Programmatic Environmental Impact Statement

Final Supplement Dealing with
Disposal of Accident-Generated Water

**U.S. Nuclear Regulatory
Commission**

NUREG-0683
Supplement No. 2
Final Report

FIGURE 4.4. Population Distribution Within a 50-Mile (80-Kilometer) Radius of Three Mile Island (data from an internal NRC document prepared by the Site Analysis Branch of the Office of Nuclear Reactor Regulation, "1981 Residential Population Estimates 0-80 Kilometers For Nuclear Power Plants")

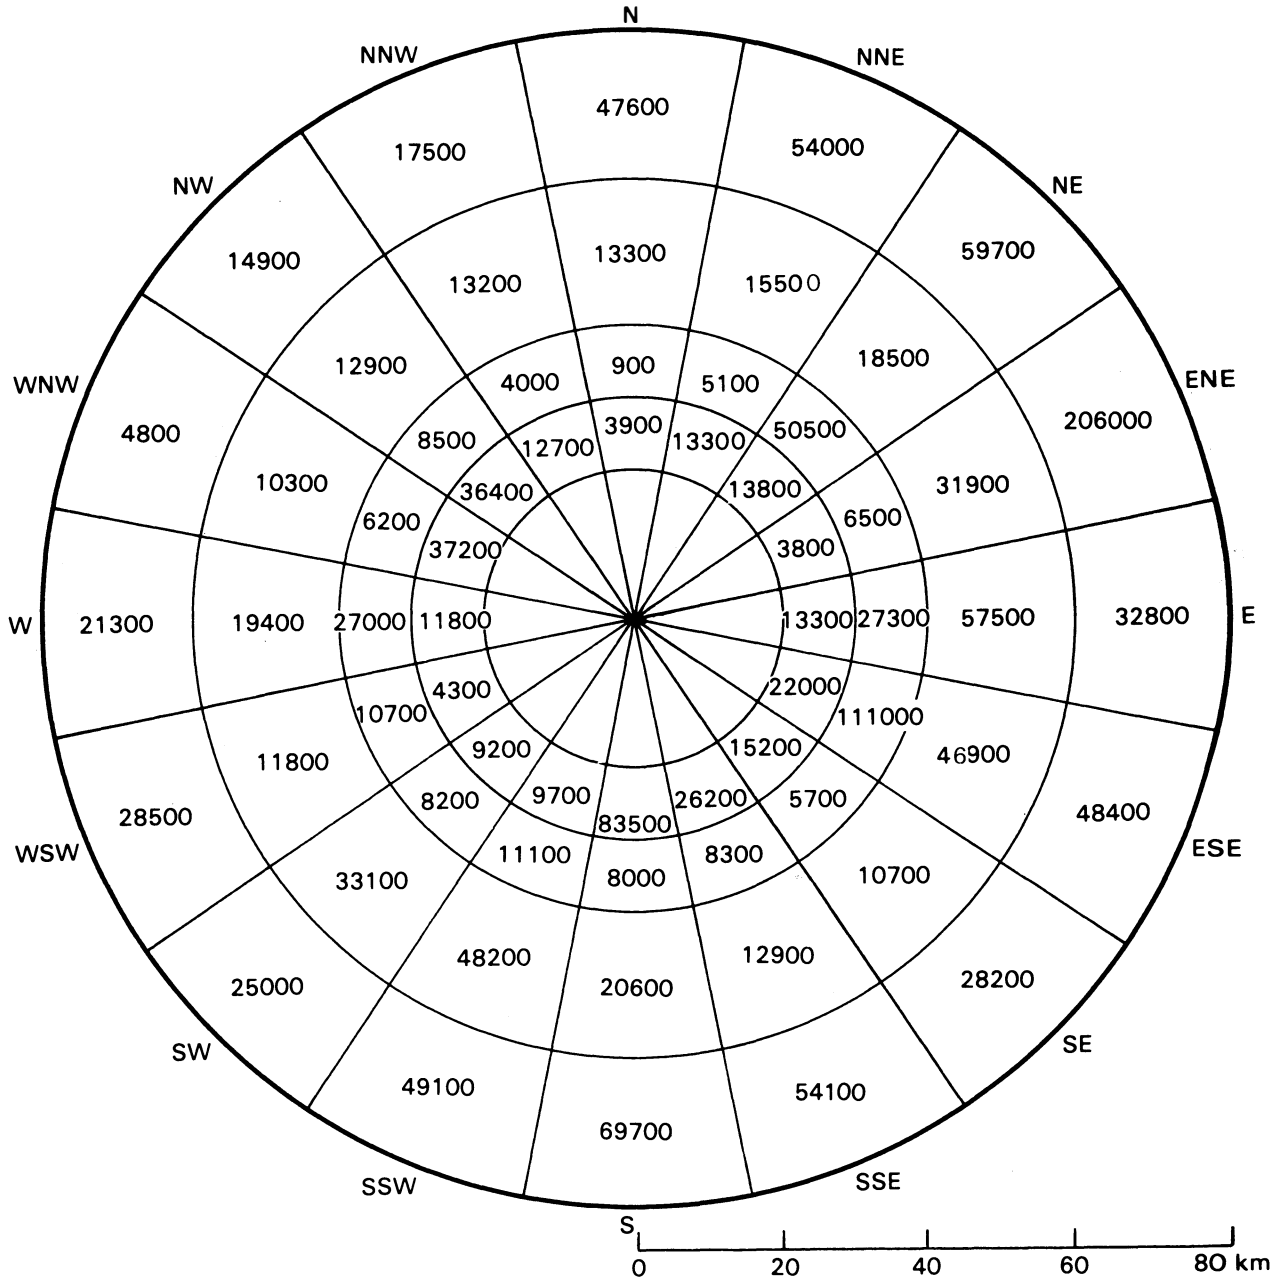
18. Section 3.5.1, page 3.31 - EPA drinking water standards for Sr-90 and Cs-137 are not mentioned.
19. Figure 4.4, page 4.5 - Population distribution is not the same as used by TMI. The population distribution used by TMI is provided in Attachment 2.

FIGURE 4.6. Principal Water Users Along the Susquehanna River in the Vicinity of Three Mile Island

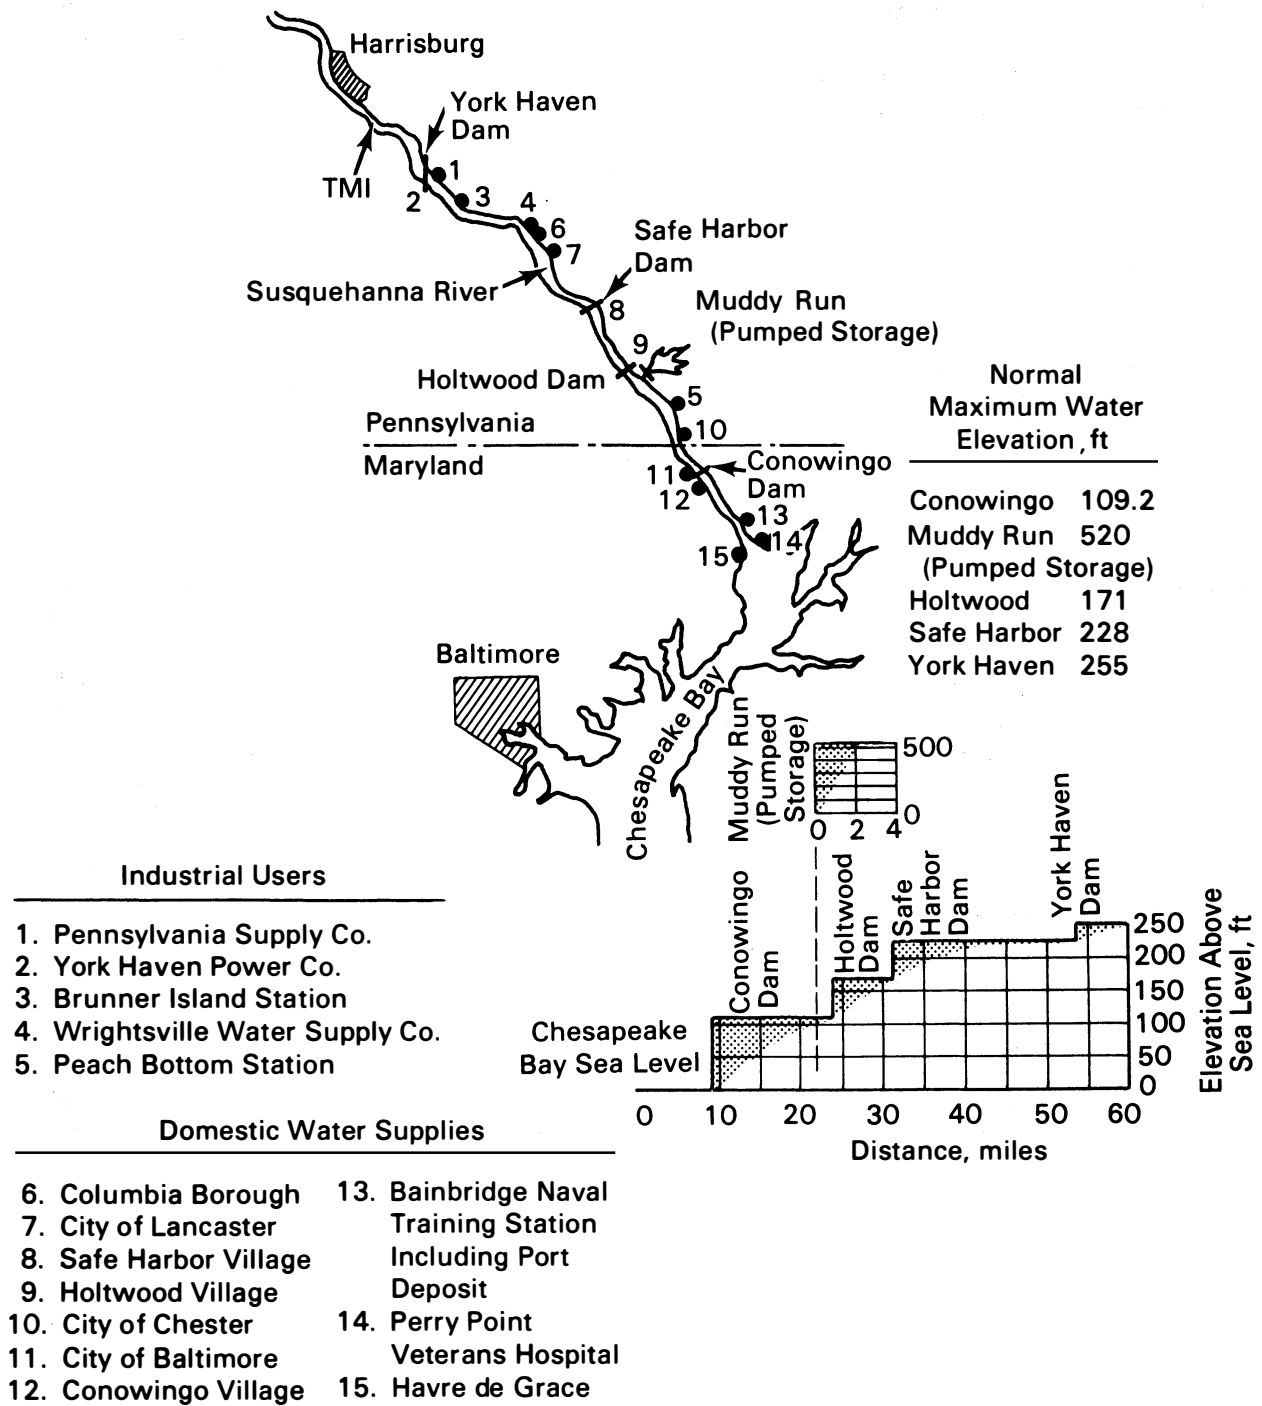
Figure 4.6 shows the four dams downstream of TMI. The models used to estimate dose assume incorporation of radionuclides in sediment and from sediment into fish. This is one of the principal reasons why the maximally exposed individual, who is assumed to have a large fish component in his diet, receives a much higher dose than average.

FIGURE 4.7. Routes to Low-Level Waste Disposal Facilities from Three Mile Island

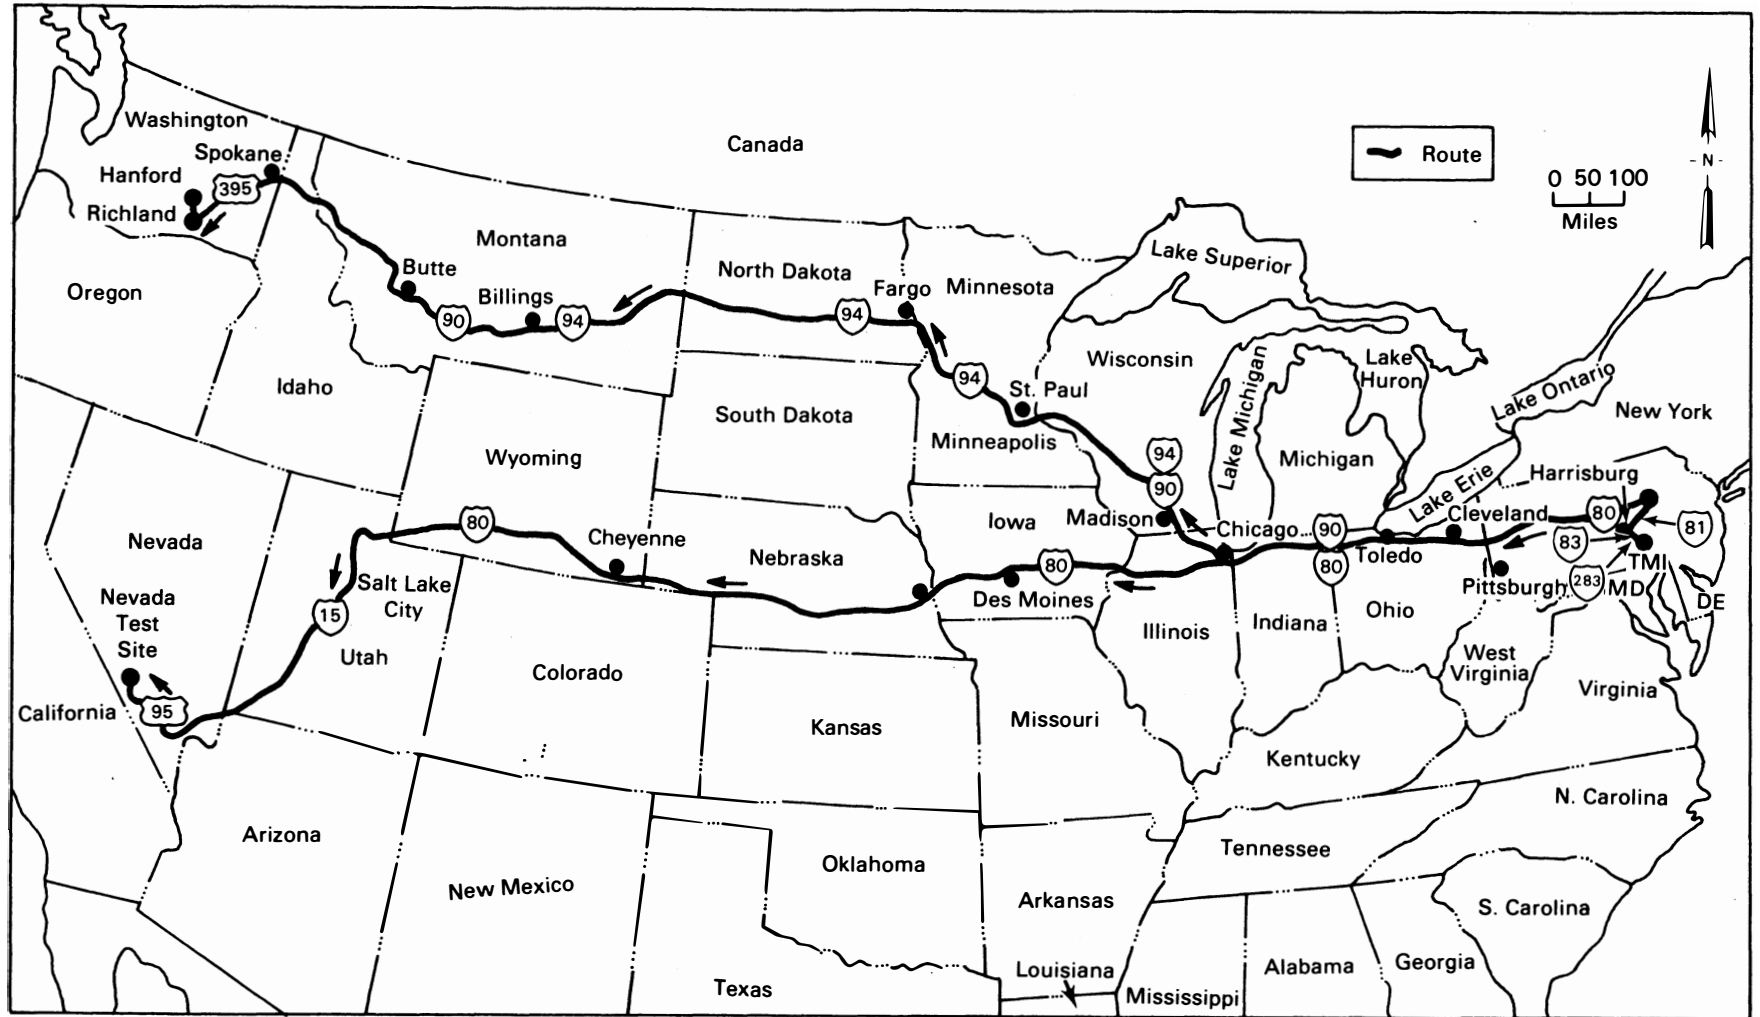
21. Page 4.13, Fig. 4.7 -- The figure shows TMI to be in the Northeast part of PA instead of the South Central, and does not show routes from TMI to Interstate Rte. 80.
